Our ref: 8100
Council ref: A004397446

**RE: Change application (Minor change) – s81 of the *Planning Act 2016*
Multiple Dwelling – 23 Units
7-9 Buruda Street, Chermside QLD 4032 (Lots 9 & 10 RP64406)**

Figure 4: Proposed Ground Floor Plan (Approved Plans overlaid in red)

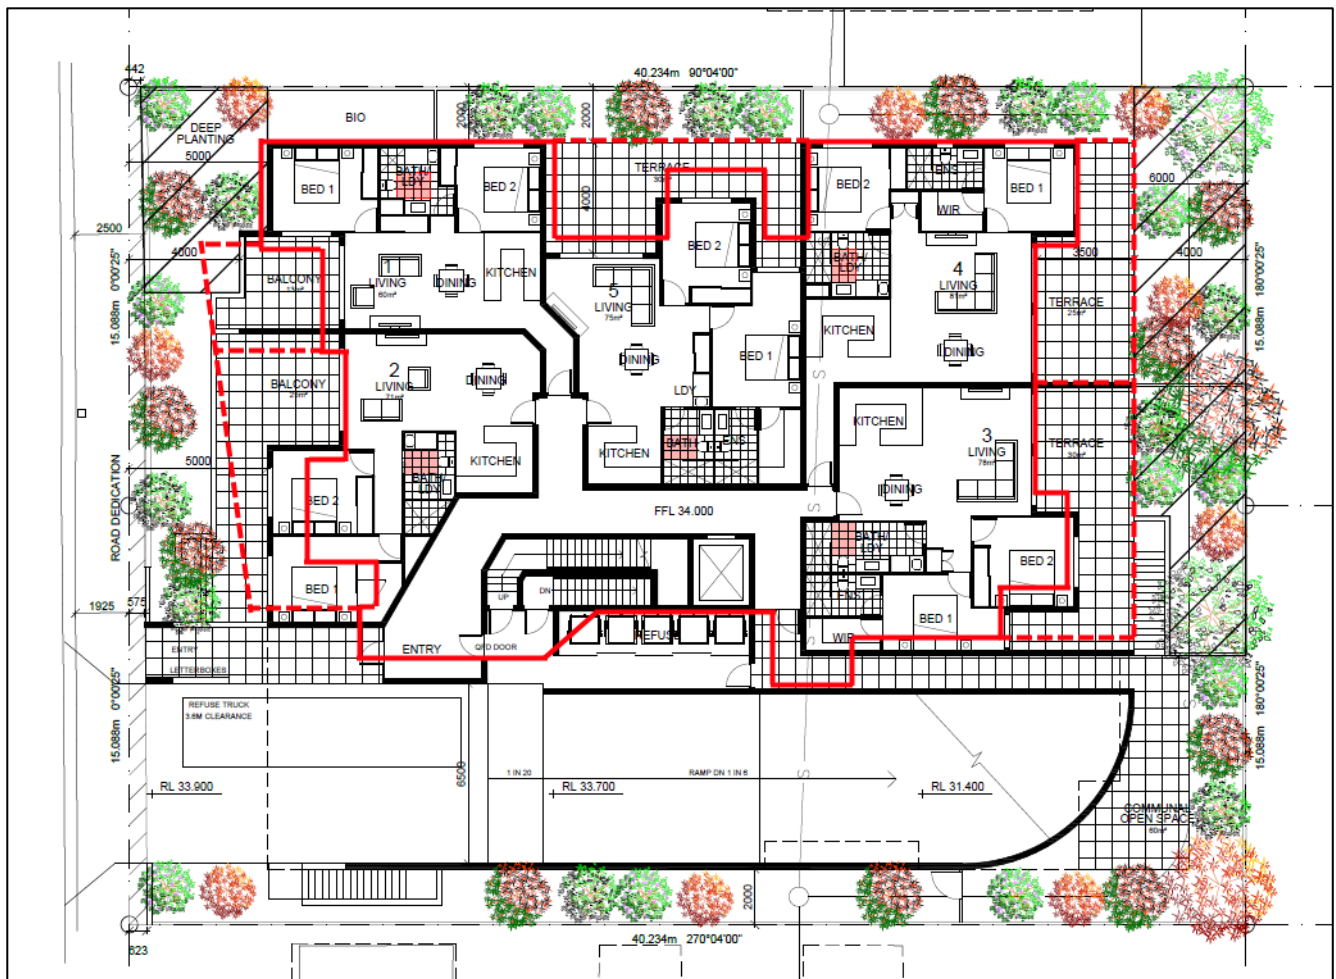
- The ground floor layout is similar to that previously approved, although Unit 2 is now slightly closer to the existing front boundary, as road widening is no longer required.
- Five (5) x 2 bedroom units are still proposed on the ground floor level although the internal layouts have been amended slightly and total GFA of the proposed units will be slightly less (8m²) than that previously approved;
- Overall, the development will still maintain the following minimum setbacks (generally consistent with the previous approval):
 - o Front: 5m setback (to wall) – this exceeds the previously approved setback of 4m (to wall);
 - o Side (North): 2m (this matches the previously approved setback);

- Side (South): 8.5m (this matches the previously approved setback);
- Rear: 6m to wall, 4m to balcony (this matches the previously approved setback);
- Minor changes to the private open space areas for each unit although all units exceed the minimum private open space areas specified in the Multiple Dwelling Code ;
- Minor changes to the refuse collection area to accommodate additional refuse bins;
- Minor changes to the lobby to increase the size of this;

A comparison of the proposed and approved building footprint is illustrated in **Figure 4** below.

Figure 5: Proposed Level 1 plan (Approved Plans overlaid in red)

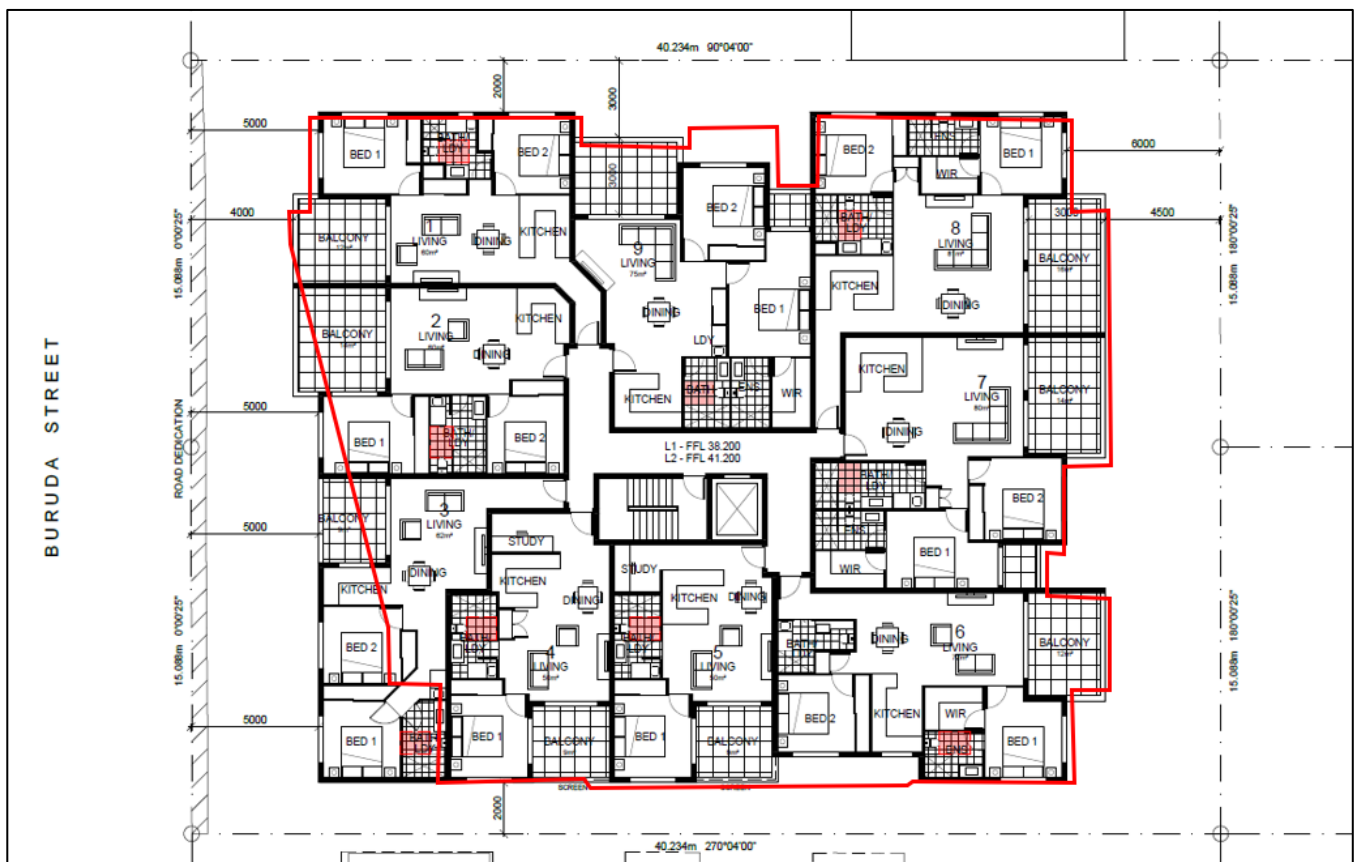
- Redesign of the Level 1 floor plan to 'straighten' the front façade as the design no longer needs to account for road widening in Buruda Street;
- The floor plans have also been reconfigured which has resulted in 2 additional units being provided . The changes are as follows:
 - Approved: 7 x 2 bedroom/2 bathroom units (average unit size of 79m²);
 - Proposed: 4 x 2 bedroom/2 bathroom units, 3 x 2 bedroom/1 bathroom units, 2 x 1 bedroom/1 bathroom units (average unit size of 65.5m²).

- Changes to balcony sizes for each unit (min 9m² and maximum 30m²). It is noted that Unit 3, 4 and 5 are only provided with a 9m² balcony (which is less than the minimum 12m² specified in AO31 of the Multiple Dwelling Code). However, it is important to note that these units are only 50 – 62m² in size internally so the slightly smaller balcony is proportional to the size of the actual units and the number of residents that are likely to utilise this space. As such, the balconies for these units are considered to be appropriately sized and located (adjoining the living spaces within the units) to enhance amenity and liveability for residents, while also being functional considering the number of residents that are likely to use this space;

- Overall, the development will still maintain the following minimum setbacks (generally consistent with the previous approval):
 - o Front: 4m (to balcony), 5m (to wall) – this matches the previously approved setback;

- o Side (North): 2m (this matches the previously approved setback);
 - o Side (South): 2m (this matches the previously approved setback);
 - o Rear: 6m to wall, 4.5m to balcony (this matches the previously approved setback);

- The changes to the building footprint is illustrated in **Figure 5** below.

Figure 6: Proposed Building Footprint compared to a compliant footprint (red dashed line)

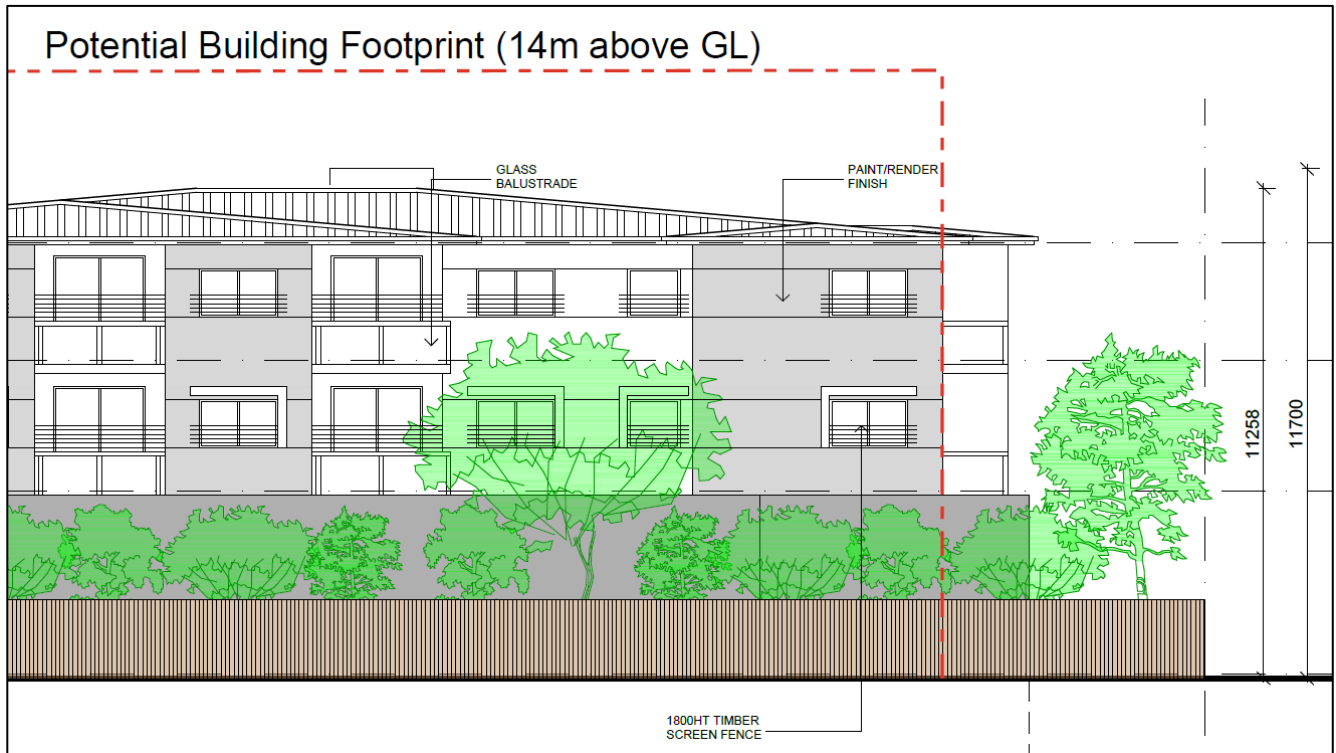
Whilst the proposal does not comply with the acceptable outcome rear setback outlined in Table 9.3.14.3.C, it is considered to satisfy PO3 of the Multiple Dwelling Code. It is noted that Table 9.3.14.3.C of the Multiple dwelling code specifies a minimum setback of 6m (to both the wall and balconies). The proposed development will be setback 6m (to the wall). However, the balconies of the rear units will be setback 4.5m from the rear boundary.

The variation is fairly minor and is not expected to result in unacceptable impacts on adjoining residential amenity. A review of aerial imagery indicates that rear setbacks within the surrounding locality commonly range between approximately 4m and 6m, demonstrating a varied setback pattern rather than a uniform built form outcome.

In this context, the proposal remains consistent with the established and anticipated character of the area. The development maintains appropriate separation to adjoining properties, provides landscaping and deep planting along the rear boundary, and ensures impacts associated with overlooking, visual dominance and overshadowing are minimised. Accordingly, the proposal achieves the intent of PO3 despite the minor setback variation.

Figure 7: Proposed Level 2 plan (Approved Plans overlaid in red)

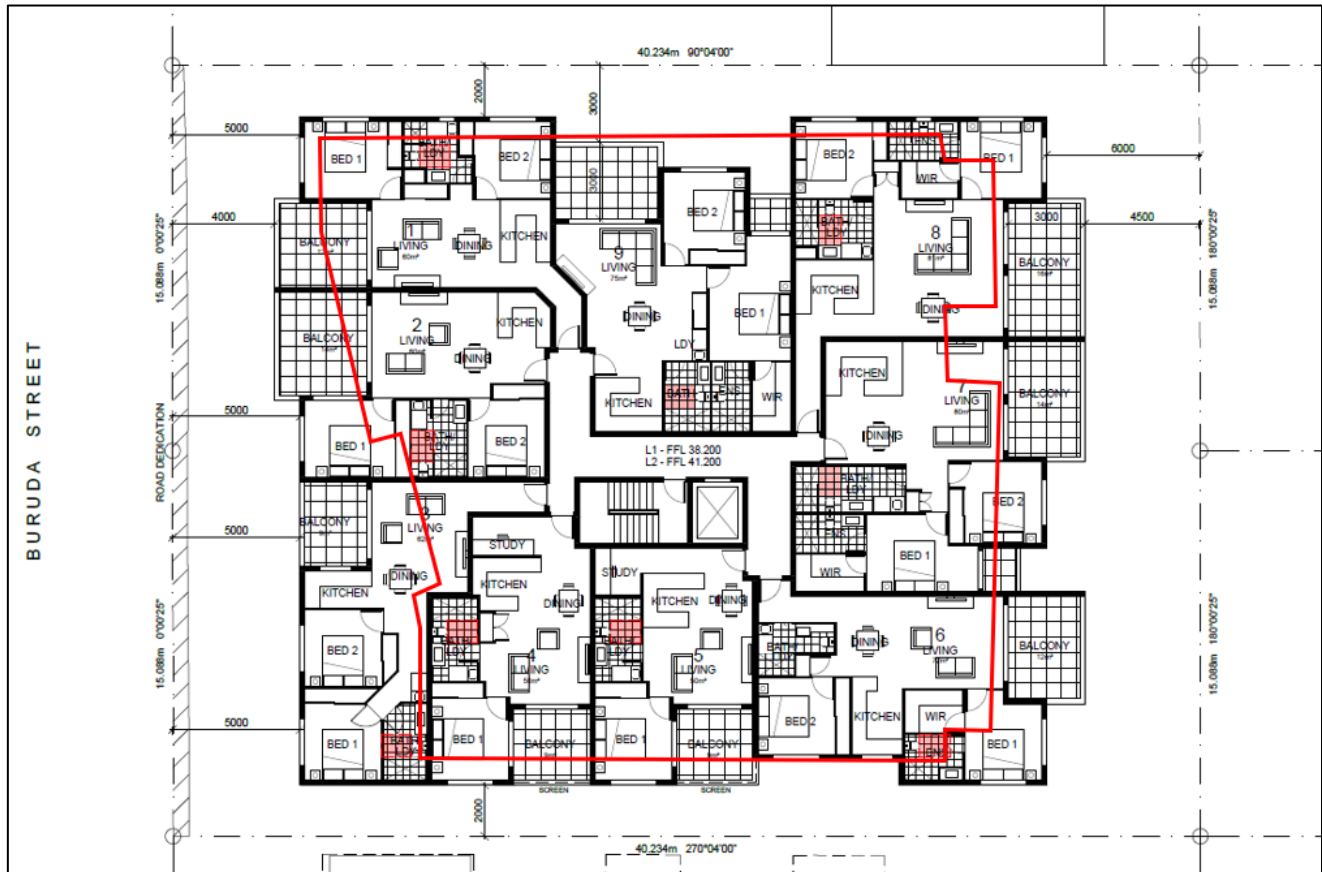
- Similar to Level 1, the Level 2 floor plan has been redesigned and reconfigured to 'straighten' the front façade as the design no longer needs to account for road widening in Buruda Street and also extend the building footprint closer to the rear boundary;

- The floor plans have also been reconfigured which has resulted in 2 additional units being provided. The changes are as follows:
 - o Approved: 6 x 2 bedroom/2 bathroom units (average unit size of 73m²);

- o Proposed: 4 x 2 bedroom/2 bathroom units, 3 x 2 bedroom/1 bathroom units, 2 x 1 bedroom/1 bathroom units (average unit size of 65.5m²).
- Changes to balcony sizes for each unit (min 9m² and maximum 30m²). As identified above, the proposed balcony sizes for each unit are considered appropriate;

- Overall, the development has the following minimum setbacks):
 - o Front: 4m (to balcony), 5m (to wall) – this is less than the previously approved setback of 6m (to balcony), 7m (to wall);

- o Side (North): 2m to wall - this is less than the previously approved setback of 3m);
 - o Side (South): 2m to wall - this is less than the previously approved setback of 3m);

- o Rear: 6m to wall, 4.5m to balcony – this is less than the previously approved setback of 8m (to balcony), 10m (to wall).

The proposed Level 2 side boundary setbacks are considered appropriate having regard to PO7 of the Multiple Dwelling Code. It is acknowledged that the Level 2 side setbacks are reduced when compared with the approved upper level setbacks. However, the amended setbacks primarily reflect the proposed design approach of aligning the Level 2 footprint with the level below, which was previously approved with a 2m side boundary setback. This allows the Level 1 and Level 2 floor plans to be repeated, resulting in a more efficient and economical building form without materially changing the overall scale, height or residential use of the approved development.

The proposed 2m side boundary setbacks remain capable of supporting the functional outcomes sought by PO7. The setbacks maintain appropriate building separation to adjoining properties and do not rely on screening as the sole means of managing privacy or amenity impacts. The amended design continues to provide opportunities for light, ventilation and outlook between buildings, while the siting of windows, balconies and internal living spaces can be appropriately managed through the proposed architectural design and existing approval conditions relating to screening and privacy.

Figure 8: Approved (left) and Proposed (right) Northern Elevation

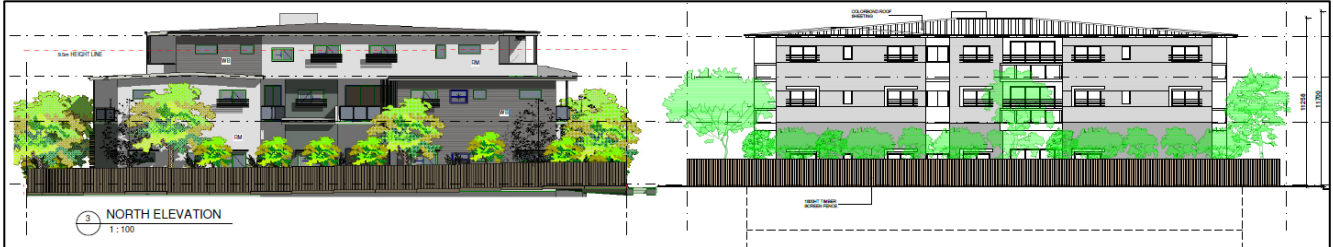
- There have been a number of changes to the facades of the proposed building in terms of location of balconies and windows and building materials, although the overall appearance of the building remains similar to that previously approved (refer to **Figure 8** to **Figure 11** below).
